FINAL PLAT
REGENCY LAKES COMMERCIAL ADDITION
AN ADDITION TO WICHITA, SEDGWICK COUNTY KANSAS

RE: S/D 9898 - One-Step Final Plat of REGENCY LAKES COMMERCIAL ADDITION

At the regular meeting of the Subdivision Committee of the Metropolitan Area Planning Commission on Thursday, October 23, 1998, the above captioned plat was considered. The action of the Committee was to recommend that this plat be approved subject to:

CASE NUMBER: S/D 98-98 - REGENCY LAKES COMMERCIAL

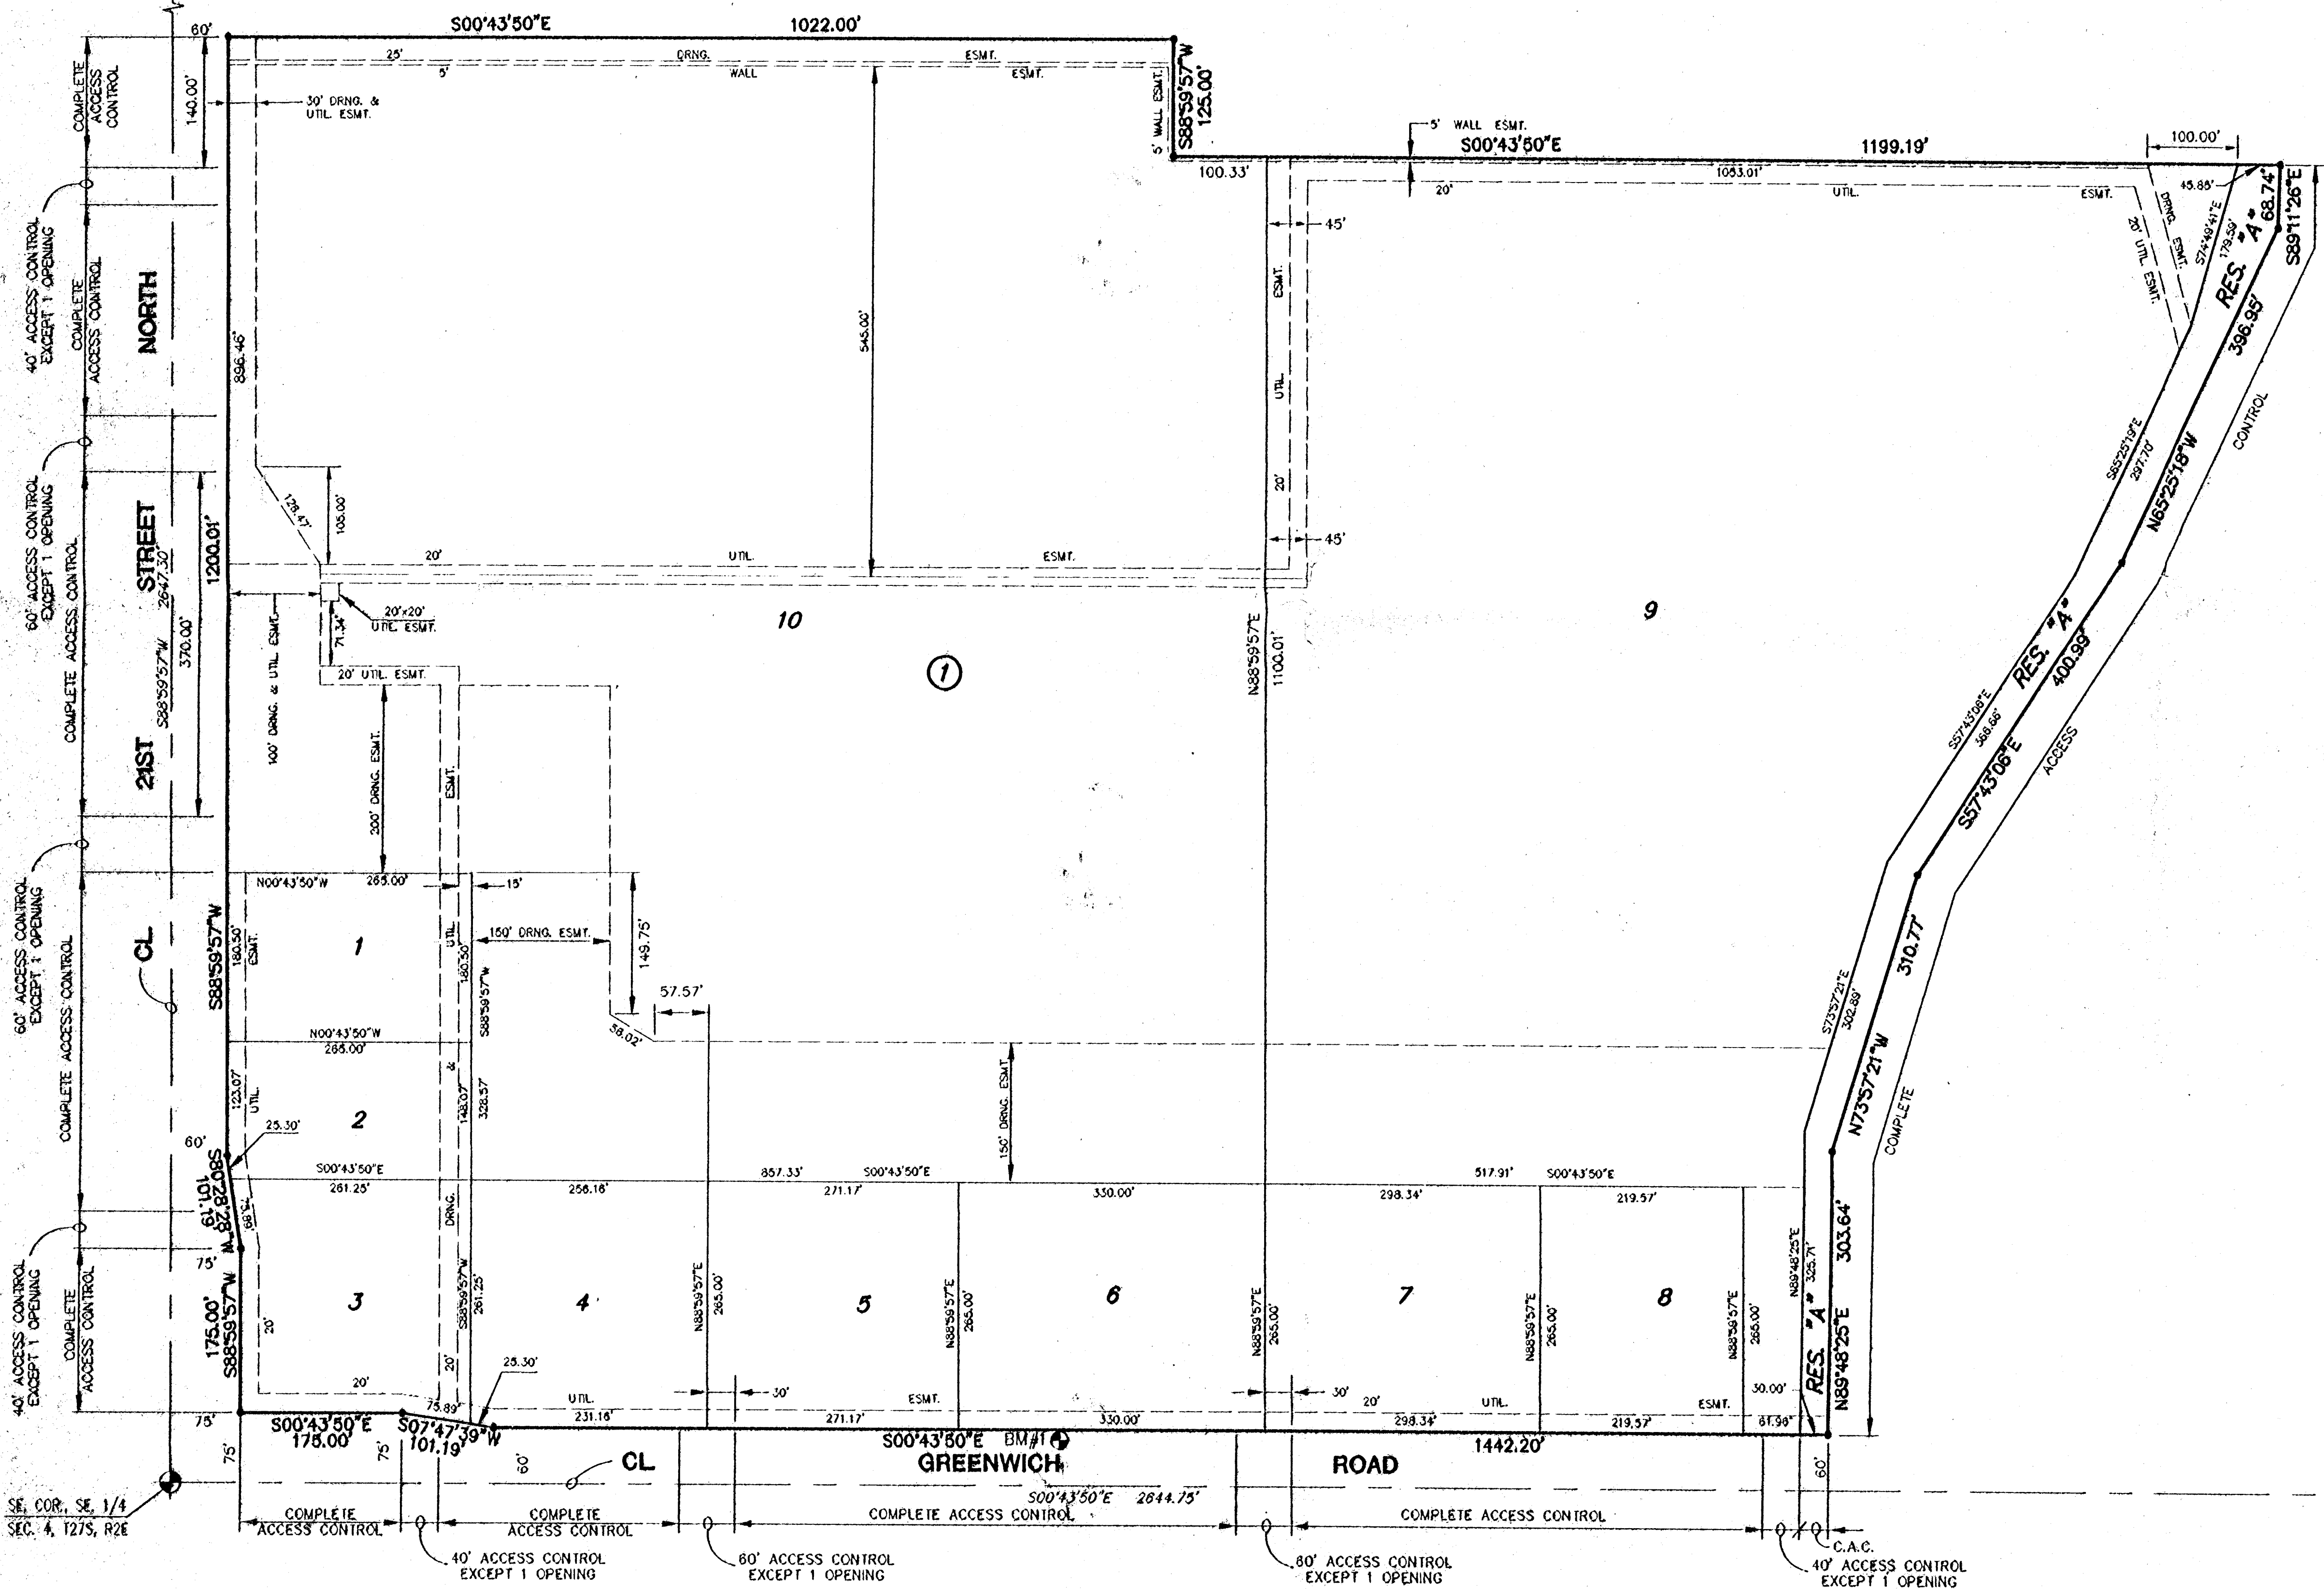
- D. In accordance with the CUP, a 5-ft wall easement needs to be platted along the west line of the plat, and shall be referenced in the plat's text.
- E. Traffic Engineering needs to comment on the need for improvements to 21st St. North and/or Greenwich. *An accel/decel lane along Greenwich will be required. The Applicant is requested to contact the developer of the Manhattan Addition to the east regarding participation in the petition for a center left-turn lane.*

- F. In accordance with the CUP, Reserve A adjoining K-96 is required to be eliminated from the CUP. This portion of the site, proposed for K-96 interchange

improvements, shall not be included within the plat's boundaries, and associated plat's text language needs to be removed.

H. Traffic Engineering needs to comment on the access controls. The CUP was approved with four points of access to 21st St. North and five to Greenwich Road. The plat denotes an additional access opening on Lot 2 along 21st St. North. The language in the plat's text regarding access to 21st St. North needs to correctly reference "Block 1". The number of access openings approved in the CUP are also approved for this plat. One opening along 21st St. North will need to be eliminated.

I. The Chairman of the MAPC needs to be revised to read, "William M. Johnson".

K. The tie points shall reference section "27S".

M. On the final plat tracing, a note shall be placed on the face of the plat indicating that this Addition is subject to the conditions of the Community Unit Plan DP-234.

O. The centerline of adjoining streets shall be indicated by "CL".

P. The plat's text shall properly reference "K.S.A. 12-512(b)".

- Z. **County Engineering requests that the City Council signature block add a statement regarding the City's agreement to the creation of a County benefit district.**
